MXR404A-01

Modification Available Performance Enhancement Service Note

MXR404A – Infiniium MXR-Series Real-Time Oscilloscope, 4GHz, 16GSa/s, 4 Ch

This is the power supply with fan (0950-6306):

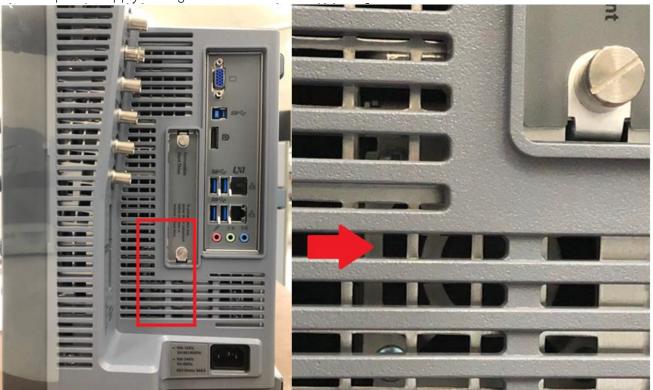
Fans located in the power supply make the oscilloscope noisy.

Install the 0950-6466 Fanless Power Supply following the instructions in the Service Guide.
